# **ENDL TEXAS**

Date: 13 June 2002  
To: T10 Technical Committee  
From: Ralph O. Weber  
Subject: Rewrite of SAM-2 example for dependent logical units to remove SCC-isms

Figure 1 — Example of hierarchical system diagram

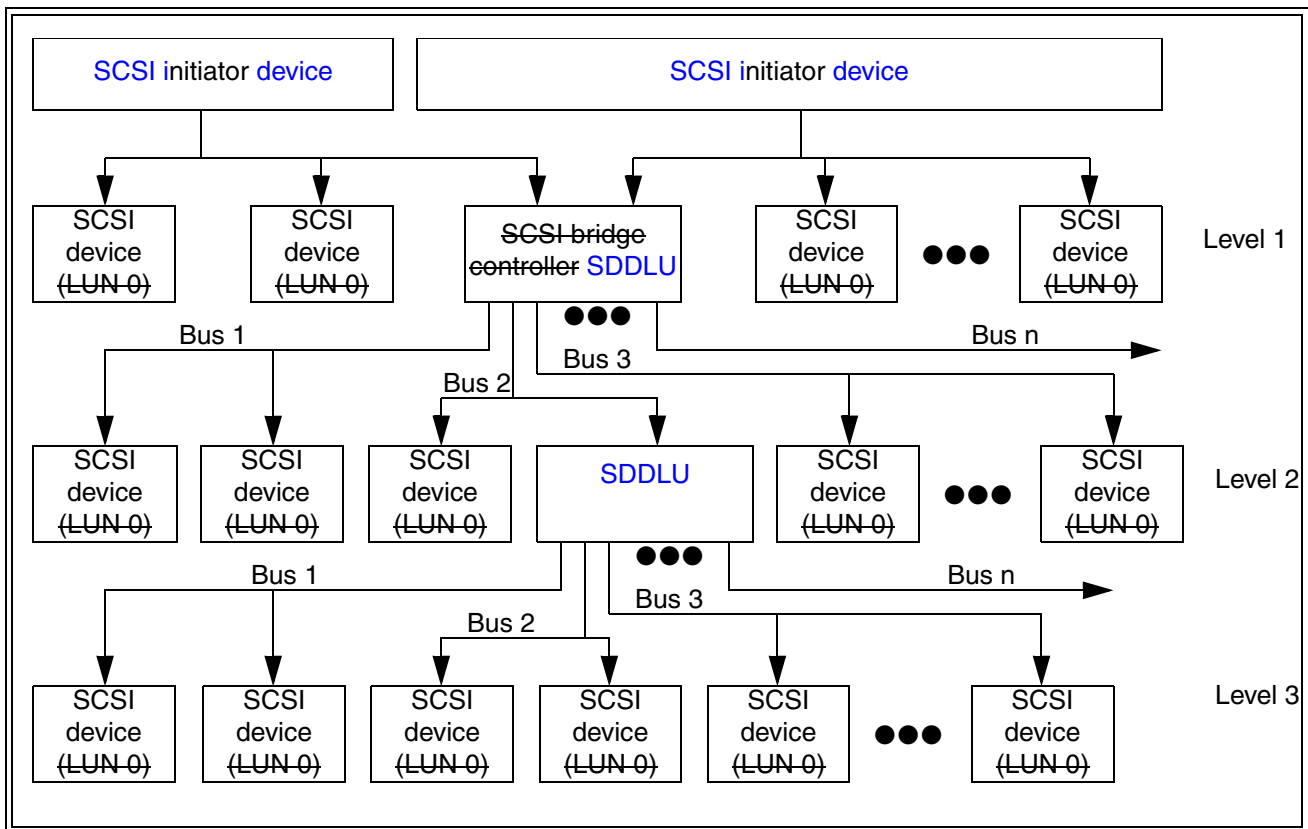
SAM-2 letter ballot comments (see 02-155r2) Cisco 10), Compaq 21), Exabyte 37), Exabyte 38), HP 61), and Maxtor 45) all raise issues regarding figure 23 (SAM-2 r23 PDF page 60) and the description of it. This proposal changes figure 23 and rewrites the text describing it in accordance with the current responses to these comments. The intent of this proposal is to allow CAP to review the result of the rewrite without having to pick through the comments responses.

Many changes are made repeatedly throughout the text. To increase readability, the existing text with strikeouts is shown only for the first occurrence of the change.

As shown in figure 1, The hierarchical logical unit structure is an inverted tree containing up to four addressable levels. The example in figure 1 is a three-level system that consists of:

- a) One SCSI initiator device that has three SCSI target devices attached on in a single SCSI bus domain that is not expandable unable to add more SCSI target devices. One of the SCSI target devices is a dual ported SCSI bridge controller the level 1 SDDLU. The level 1 SDDLU has two SCSI target ports, one in each of the SCSI domains containing a SCSI initiator device-;

- b) One SCSI initiator device has three SCSI target devices attached in a single SCSI domain that is expandable able to add more SCSI target devices. One of the SCSI target devices contains is a dual ported SCSI bridge controller the level 1 SDDLU;

- c) The level 1 SDDLU has three SCSI domains (called buses for hierarchical addressing purposes) with SCSI target devices attached and is capable of driving connecting more SCSI domains;

- A) Two of the SCSI domains contain two SCSI target devices each and these SCSI domains are unable to add more SCSI target devices. One of the SCSI target devices is the level 2 SDDLU;

- B) One of the SCSI domains contains two SCSI target devices and is able to add more SCSI target devices;
- C) The level 2 SDDLU has three SCSI domains with SCSI target devices attached and is capable of connecting more SCSI domains;

- a) Two of the SCSI domains contain two SCSI target devices each and these SCSI domains are unable to add more SCSI target devices; and
  - b) One of the SCSI domains contains two SCSI target devices and is able to add more SCSI target devices.
